Access Compliance Report

(Curb Ramps)

Intersection ID: 14441	Main Street: E_KINGSTON_AV	Cross Street: SPRINGDALE_AV	Location: E
ADA ID: F51636C5CA78	Ramp Type: Perp	Initial Pass/Fail: Fail	Overall Compliance: No
Severity Score: 13.75			
Codes/Mitigation Info/Possible Solution		Field Measurements/Component Compliance

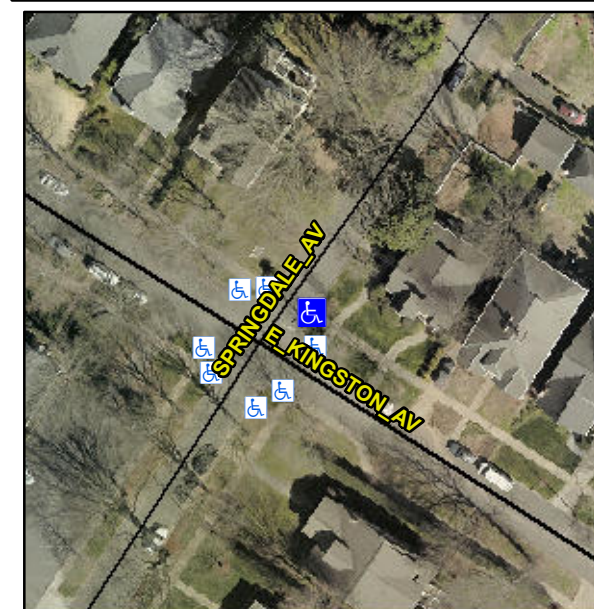
Not Found, R304.2.2, R304.5.3

Compliance	Description	Data	Compliance	Description	Data
N/A	Ramp Length (in)	67.0	No	Ramp Slope (%)	11.6
Yes	Ramp Width (in)	49.0	No	Ramp XSlope (%)	4.2
N/A	Flare Type LT	N/A	N/A	Flare Type RT	N/A
N/A	Flare Slope LT (%)	N/A	N/A	Flare Slope RT (%)	N/A
N/A	Flare Traversable LT?	N/A	N/A	Flare Traversable RT?	N/A
N/A	Landing Length (in)	N/A	N/A	DWS Provided?	N/A
N/A	Landing Width (in)	N/A	N/A	DWS Contrast?	N/A
N/A	Landing Slope (%)	N/A	N/A	DWS Length (in)	N/A
N/A	Landing X Slope (%)	N/A	N/A	DWS Full Width?	N/A
N/A	Landing Curb? (Y/N)	N/A	N/A	DWS Offset (in)	N/A
N/A	Shared Landing?	N/A			
N/A	Gutter Ponding?	N/A	N/A	Gutter Slope (%)	N/A
N/A	Gutter Lip Ht (in)	N/A	N/A	Gutter X Slope (%)	N/A
N/A	Painted X Walk1?	No	N/A	Painted X Walk2?	N/A
	X Walk 1 Direction	To NW		X Walk 2 Direction	N/A
N/A	X Walk 1 Width (in)	N/A	N/A	X Walk 2 Width (in)	N/A
	X Walk 1 Slope (%)	6.0		X Walk 2 Slope (%)	N/A
	X Walk 1 X Slope (%)	2.7		X Walk 2 X Slope (%)	N/A

Remove & Replace Entire Ramp.
